Procter & Gamble Cogeneration Project

**FIRST AMENDMENT OF THE PROCTER AND GAMBLE COGENERATION PROJECT
AFC (DOCKET NO. 93-AFC-2) -- REALIGNMENT OF A PORTION OF THE 230kV
TRANSMISSION LINE**

**REALIGNMENT OF A PORTION OF THE 230 kV
TRANSMISSION LINE FOR THE PROCTER AND
GAMBLE COGENERATION PROJECT.**

**AMENDMENT 1
DECEMBER 23, 1993**

Project No. 92C0016A	Procter & Gamble AFC Amendment	PROPOSED 230 kV TRANSMISSION LINE REALIGNMENT	Figure 1
Woodward-Clyde Consultants

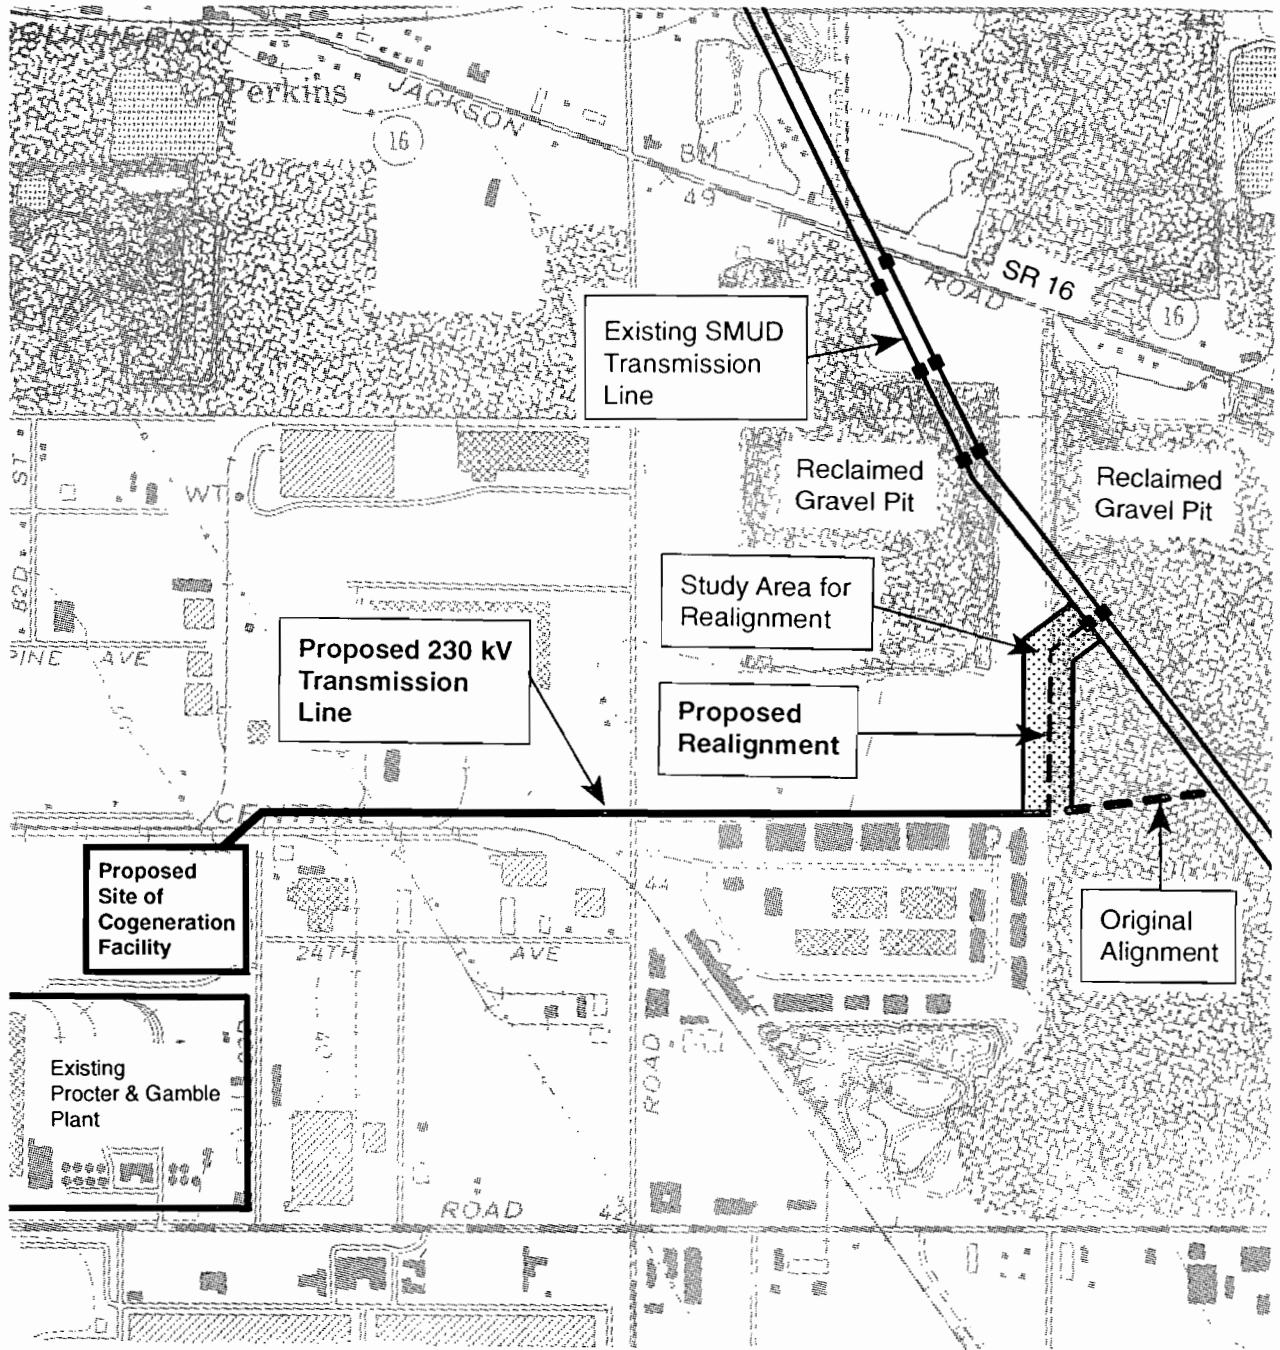
A proposed transmission line would connect the Procter and Gamble Cogeneration Facility with the existing SMUD 230 kV Hedge to Hurley transmission line approximately 1.3 miles east of the project site (Figure 1). The proposed route of the transmission line occupies an east-west corridor between the existing SMUD transmission line right-of-way and the proposed cogeneration facility. The proposed alignment would cross to the north side of the railroad tracks immediately north of the project site. The transmission line would then turn east, cross Florin-Perkins Road, parallel the north side of an industrial park and cross a reclaimed aggregate quarry to intersect the 230 kV Hedge to Hurley transmission line.

Approximately 0.2 mile at the eastern end of the original alignment described in the AFC would be realigned. The new alignment would make a 90-degree turn to the north approximately 1.1 mile east of the project site, and would intersect the Hedge to Hurley 230 kV transmission line approximately 0.3 mile north of the point of deviation from the original route. The realignment would have a 60 foot wide right-of-way.
